Item ID: D407-667-105TRN Accept ***N900040100*** Setup Start ***NS1***
 Revision ID: Stop ***NS2***
 Item Name: Crosstube Turning Detail
 Start Date: 2/3/2015 Start Qty: 1.00 ***1*** Cust Item ID:
 Required Date: 2/3/2015 Req'd Qty: 1.00 ***1*** Customer:
 Reference:

DART AEROSPACE LTD		Work Order: 129293
Description: Crosstube Assembly		Part Number: D407-667-145
Inspection Dwg: D407-667-145 Rev: C		Page 1 of 2

DRAWING NO. D407-667-145	TITLE CROSSTUBE ASS'Y (407 HIGH FWD)	REV. C	DART AEROSPACE LTD ENGINEERING ORDER		D.E.O. NO. D407-667-145-C-1	SHEET NO. SHEET 1 OF 1	SCALE NTS
DRAWN 92	CHECKED ASS	MFG. APPR. 128	APPROVED WD		DE APPR. H		
DATE 11.07.15	DATE 11.07.22	DATE 11.07.22	DATE 11/07/22		DATE 11.07.21

DRAWING NO. D407-667-145	TITLE CROSSTUBE ASS'Y (407 HIGH FWD)	REV. C	DART AEROSPACE LTD ENGINEERING ORDER		D.E.O. NO. D407-667-145-C-2	SHEET NO. SHEET 1 OF 1	SCALE NTS
DRAWN AJS	CHECKED A	MFG. APPR. E	APPROVED AP		DE APPR. JH		
DATE 12.08.02	DATE 12.08.02	DATE 12.08.02	DATE 12.08.02		DATE 12.08.02

DETAIL P
BONDING STRAP INSTALLATION 2 PL

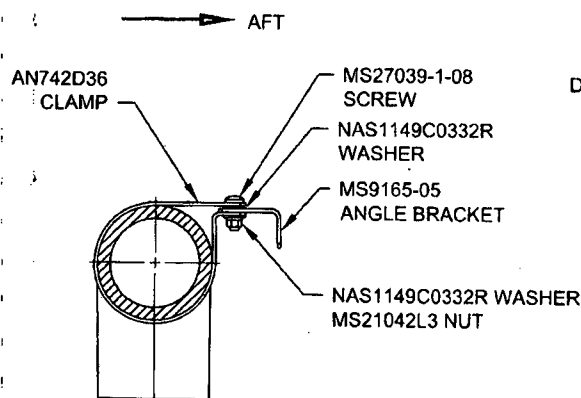
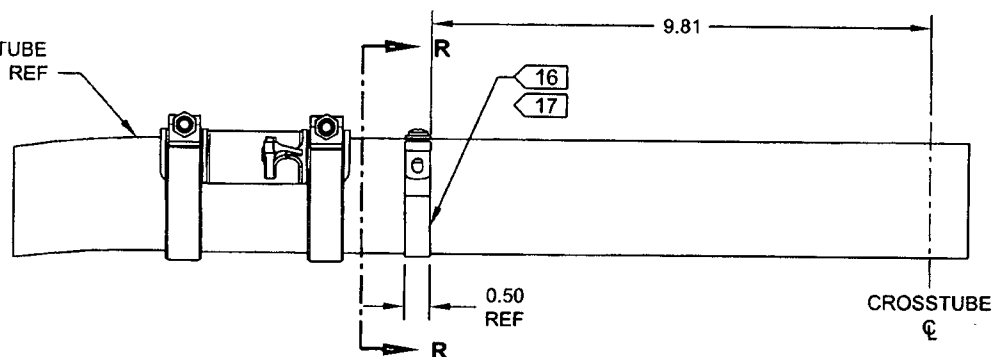
ADD ELECTRICAL GROUNDING STRAP

ITEM	QTY -145	PART NUMBER	DESCRIPTION
1	X	D407-667-145	CROSSTUBE ASSEMBLY (407 HIGH FWD)
⚡			
10	2	AN742D36	CLAMP
11	2	MS9165-05	ANGLE BRACKET
12	2	MS21042L3	NUT (OR MS21042-3)
13	2	MS27039-1-08	SCREW
14	4	NAS1149C0332R	WASHER (OR AN960C10L)

- 16) MASK AREA UNDER CLAMP PRIOR TO PAINTING
- 17) SEAL EDGES WHERE AN742D36 CLAMP MEETS WITH THE CROSSTUBE USING SIKAFLEX-241/-291 OR MIL-S-8802 CLASS B2 OR PROSEAL 890 SEALANT
- 18) PERFORM RESISTANCE CHECK TO ENSURE MAX RESISTANCE IS 10 MILLIOHMS
